HAMMOND REEF GOLD PROJECT
CORRECTIONS TO THE VERSION 3 – AMENDED
ENVIRONMENTAL IMPACT STATEMENT / ENVIRONMENTAL ASSESSMENT REPORT

Revision 1 – May 2018

HAMMOND REEF GOLD PROJECT CORRECTIONS TO THE VERSION 3 AMENDED EIS/EA

This Corrections Document provides corrections and additions to the Version 3 Amended Environmental Impact Statement/Environmental Assessment (EIS/EA) for the Hammond Reef Gold Project (the Project), as identified by the joint Federal-Provincial Government Review Team (GRT). The corrections and additions are organized with headings that reflect the organization of the Version 3 Amended EIS/EA. It is recommended that the reviewer consult this document during review of the Version 3 Amended EIS/EA. These corrections in no way change the overall conclusions and determinations of significance as indicated in the Version 3 Amended EIS/EA.

Map MNR 5: Tailings Pipeline Containment Areas

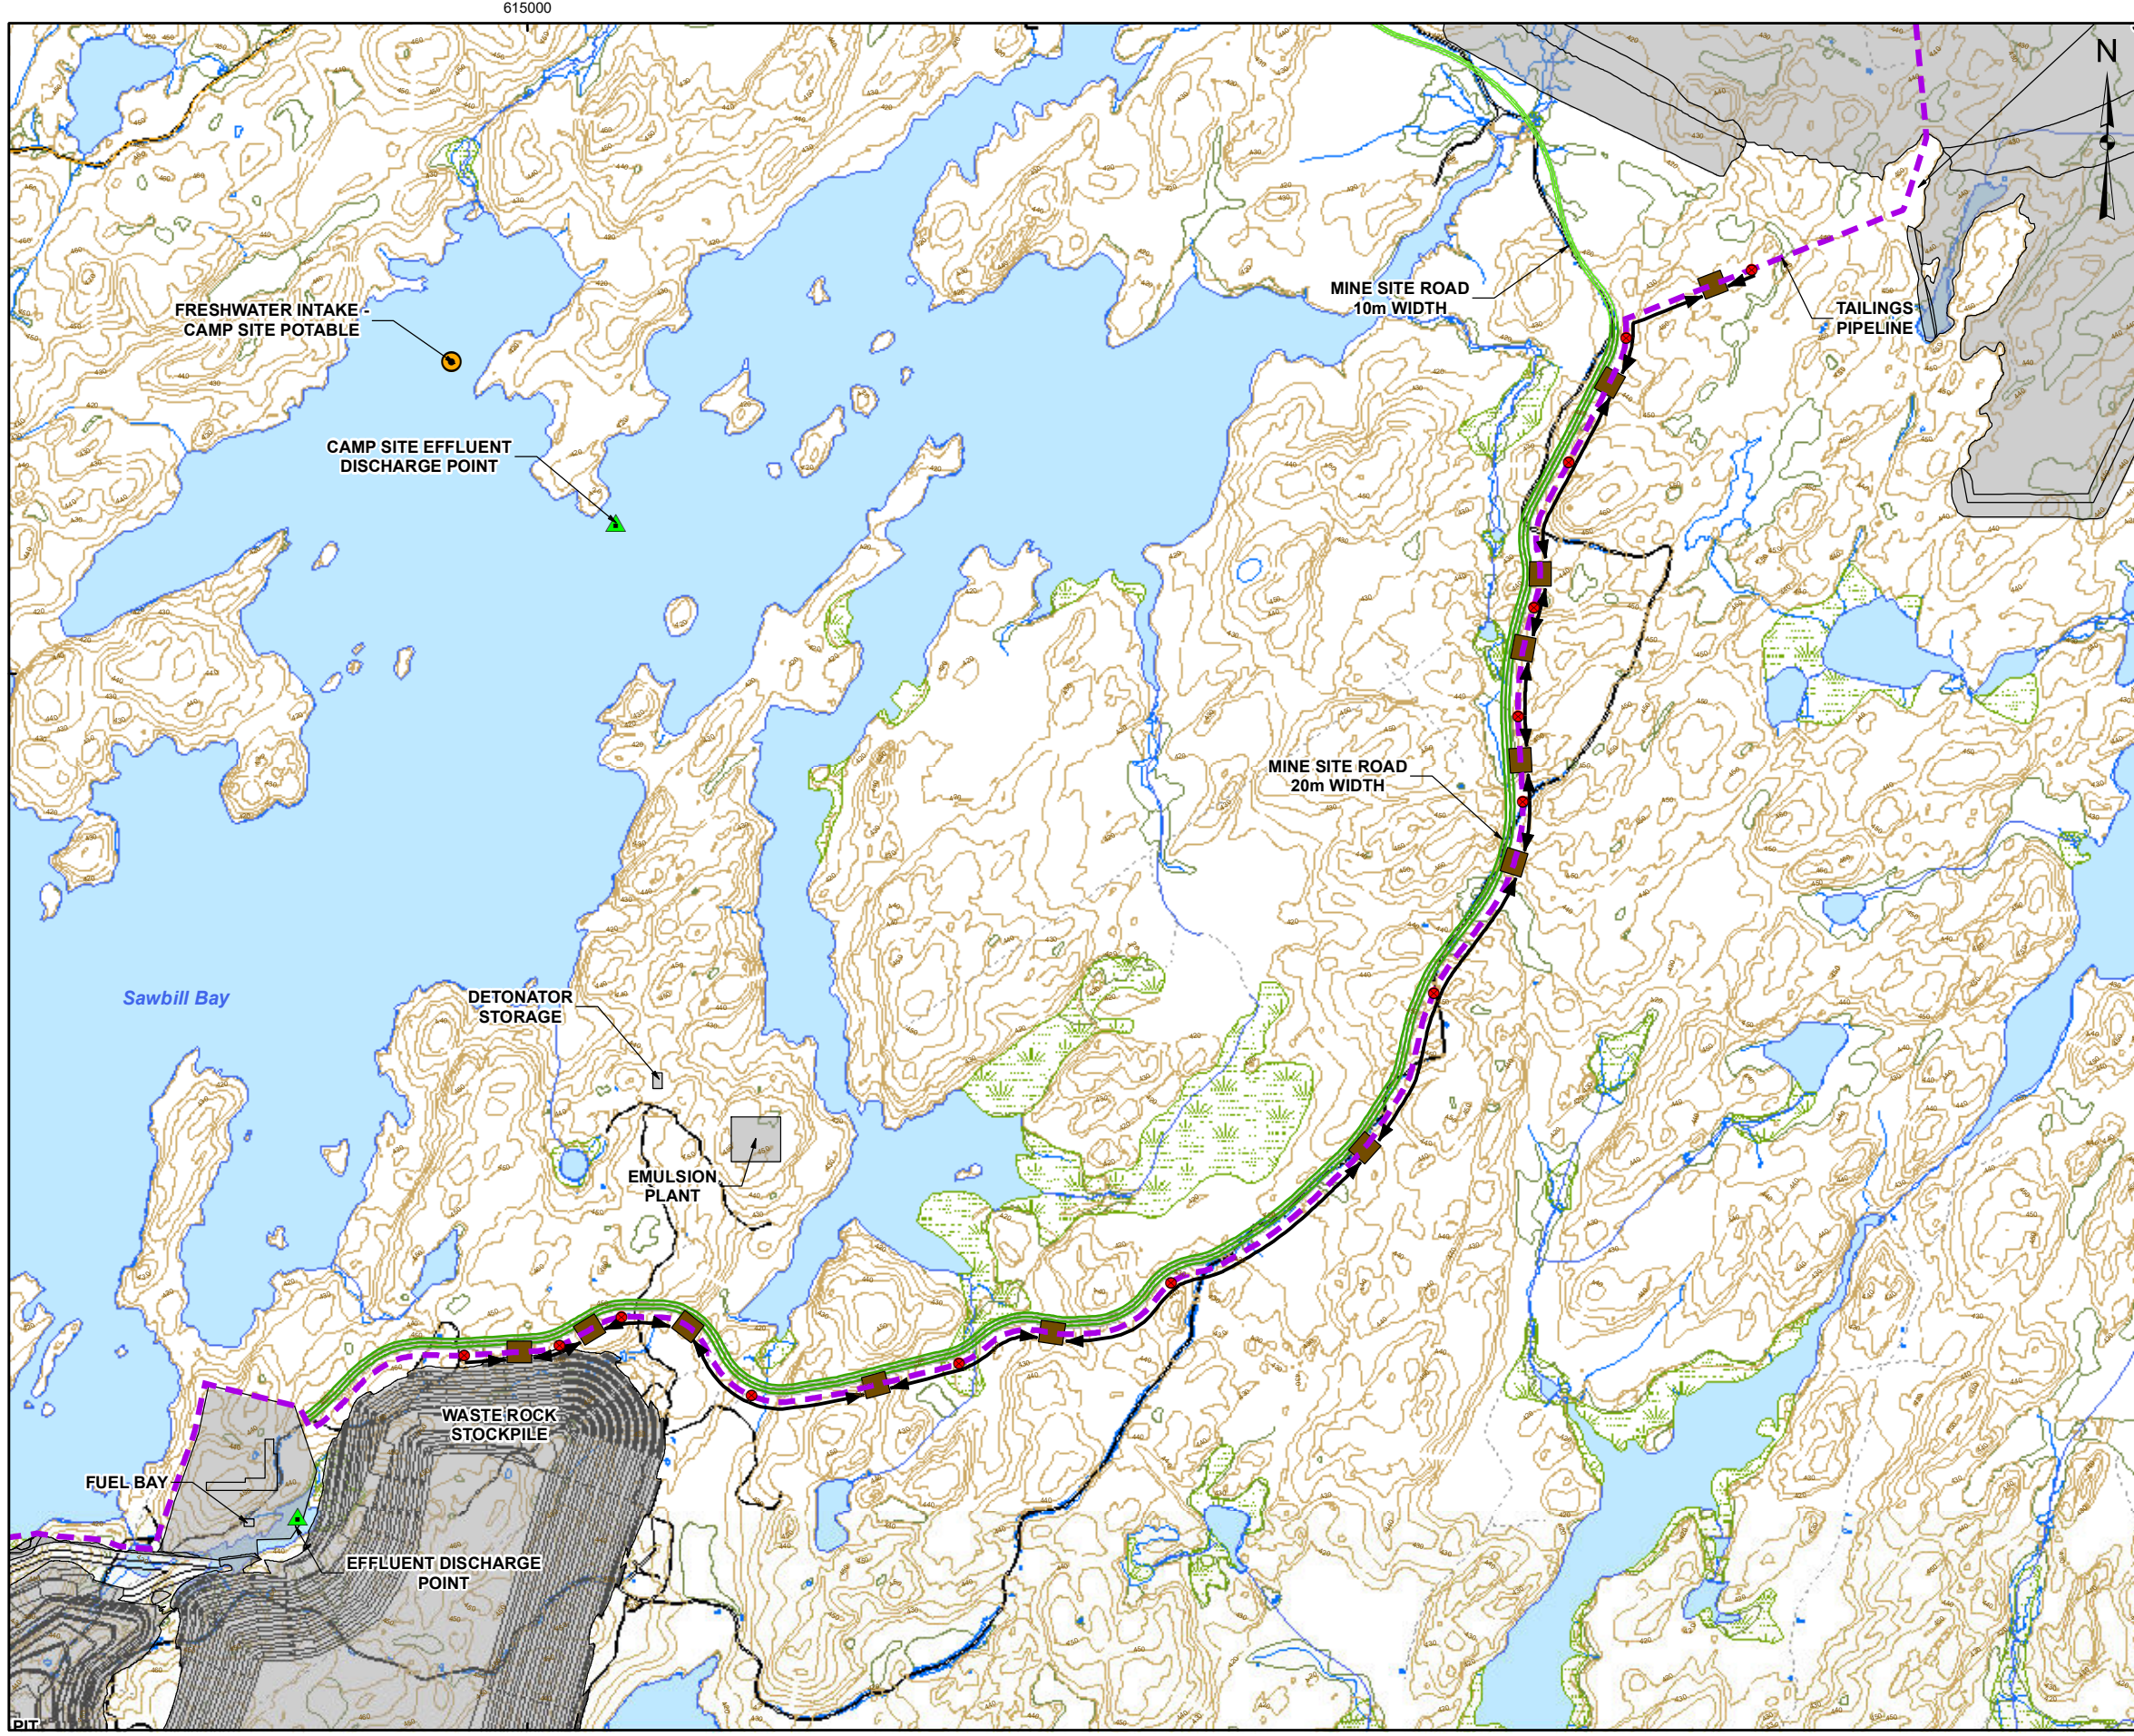
The response to MNR-5 references a map showing the site topography and the currently planned pipeline alignment and spill containment areas. However, the map was not provided in the Version 3 Amended EIS/EA. This map is provided as Attachment G of this Corrections Document.
